**Packet Guide**  
**City of Charlottesville**  
**Board of Architectural Review**  
**Regular Meeting - \*Rescheduled from 2/19/2025**  
**\*February 26, 2025 5:30 p.m.**  
**Hybrid Meeting (In-person at Council Chamber and virtual via Zoom)**

7. **Certificate of Appropriateness Application**  
BAR # HST24-0047  
1000 Wertland Street, TMP 100038000  
(1010 Wertland St; 129 10th St NW; Portion of 1105 W. Main St.)  
West Main Street ADC District  
Owner: UVA Foundation  
Applicant: Elizabeth Chapman; Grimm + Parker Architects  
Project: Multi-story residential building

**BAR MINUTES – DRAFT**  
**CITY OF CHARLOTTESVILLE**  
**BOARD OF ARCHITECTURAL REVIEW**

① CANOPY DETAIL

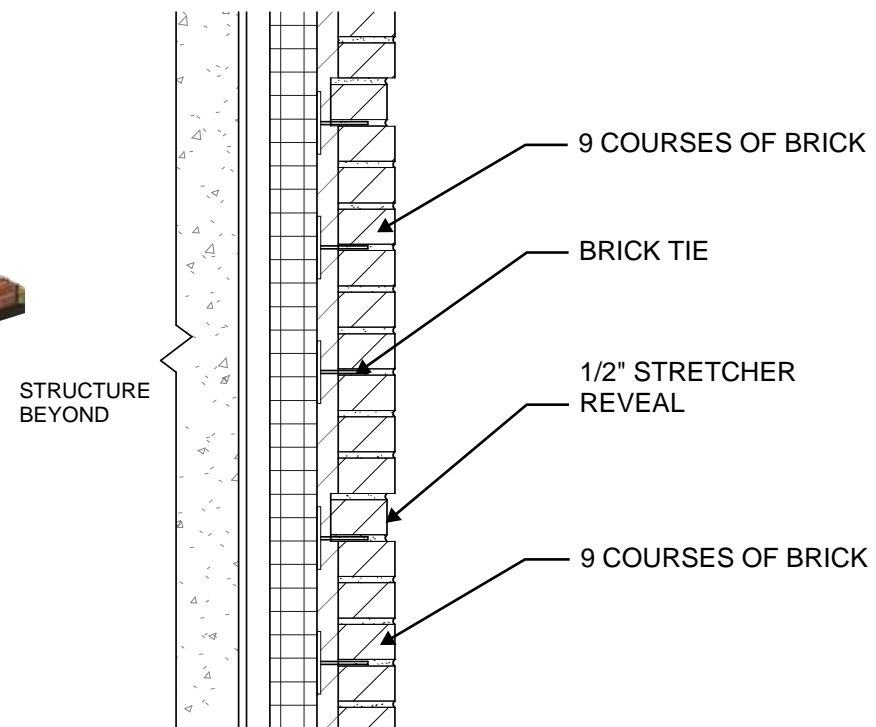
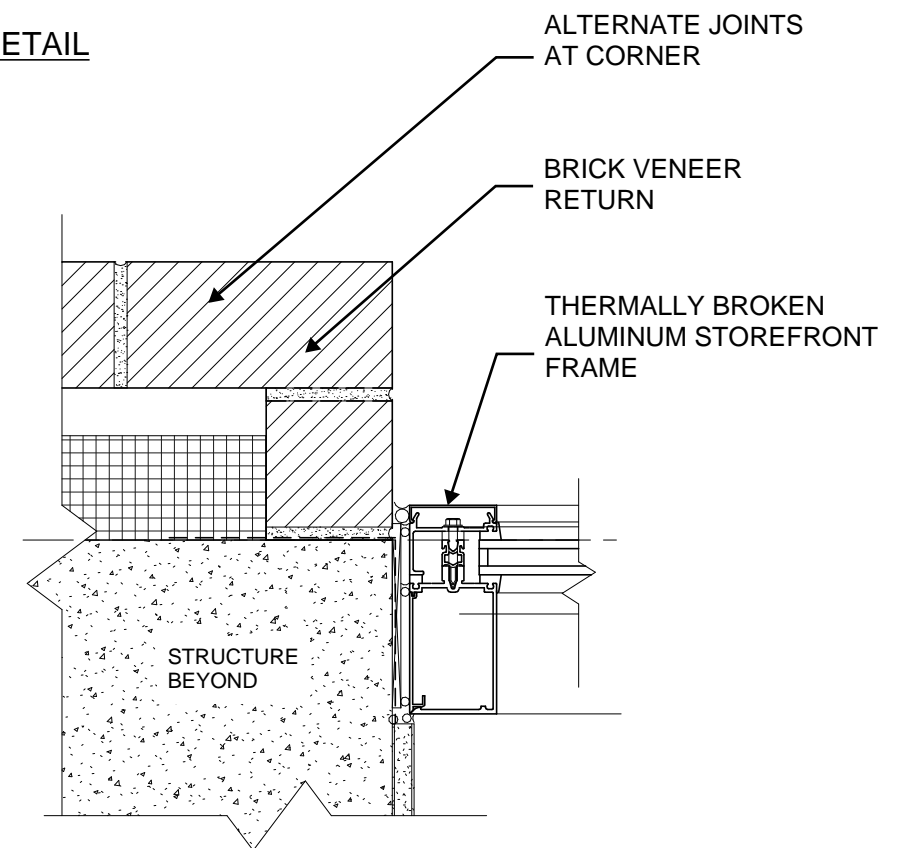
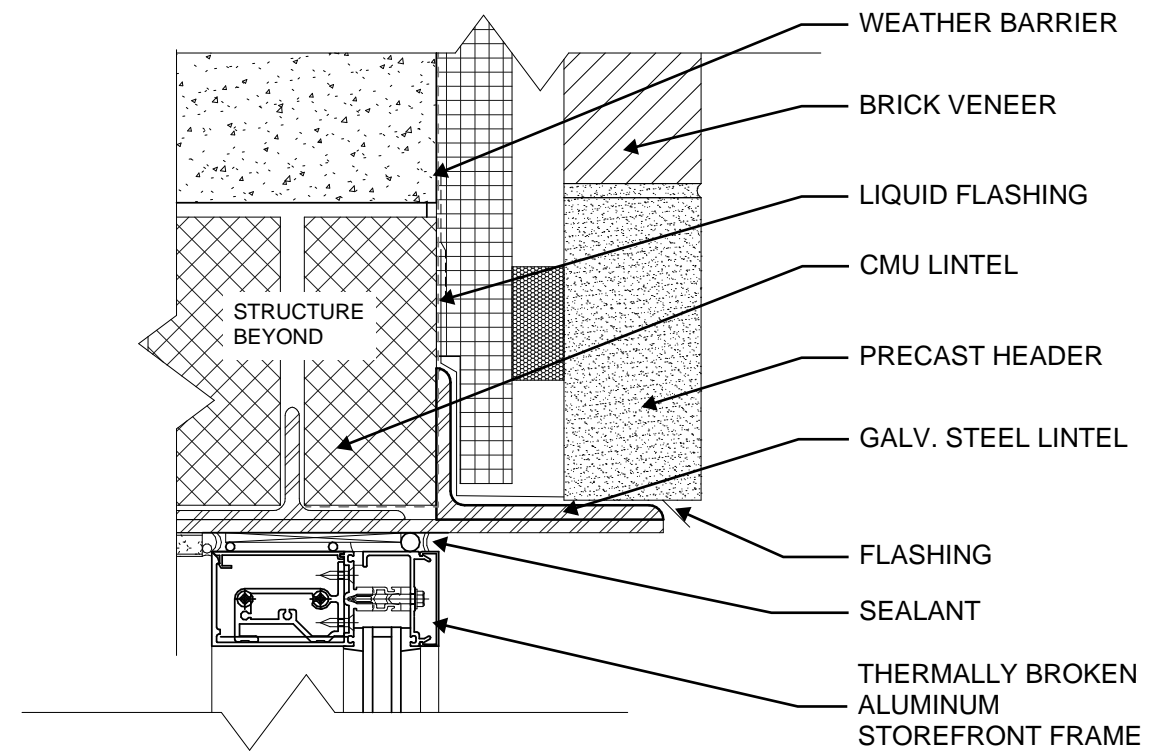
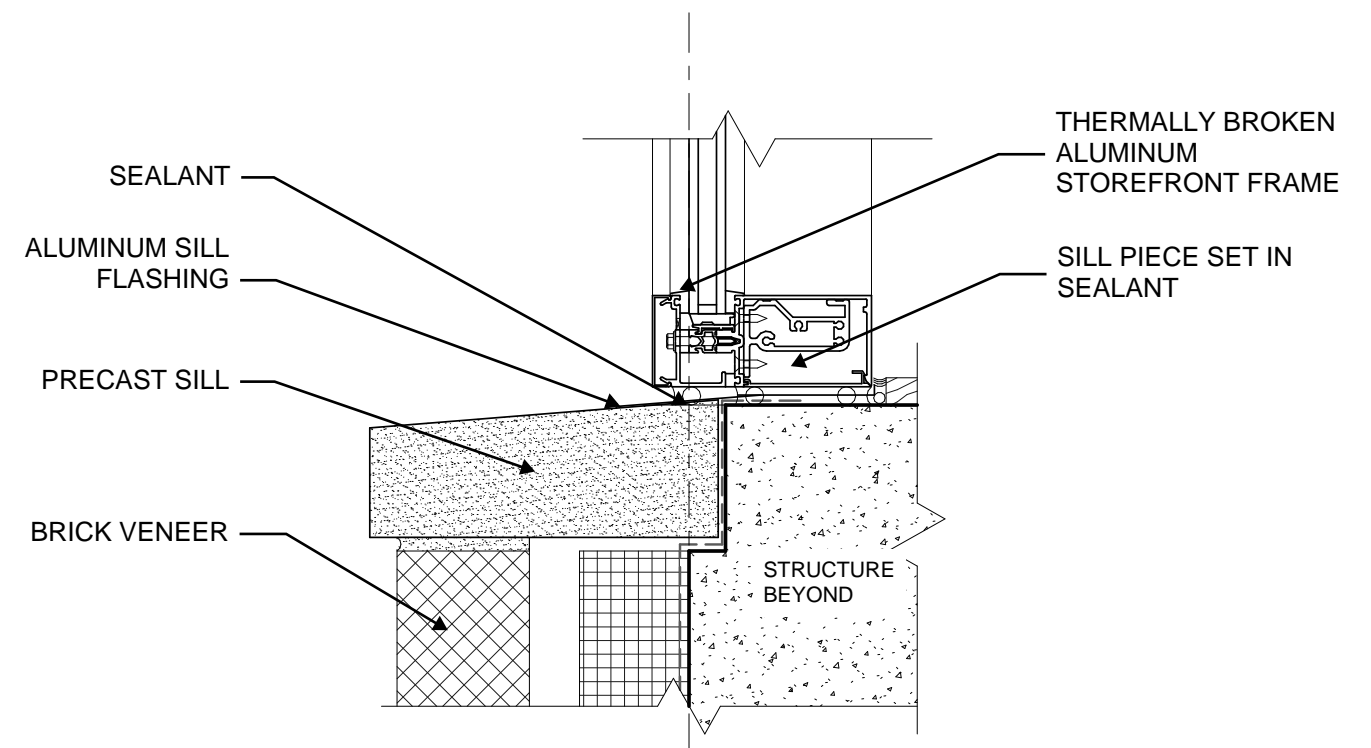
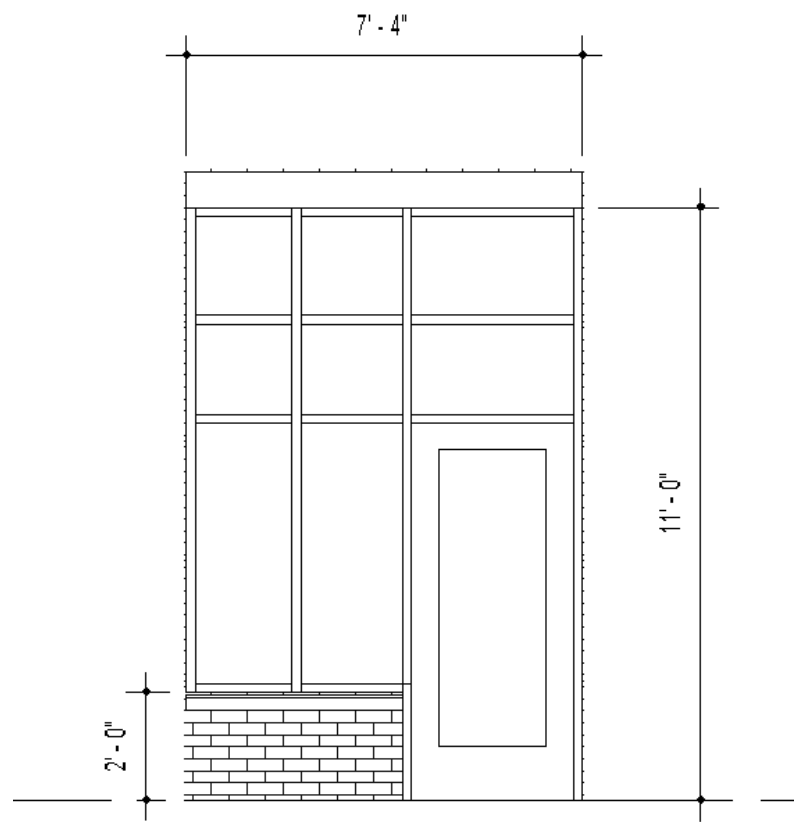
**Ms. Lewis** – With the detail on the new front door entrance, I did not see any detail on it.
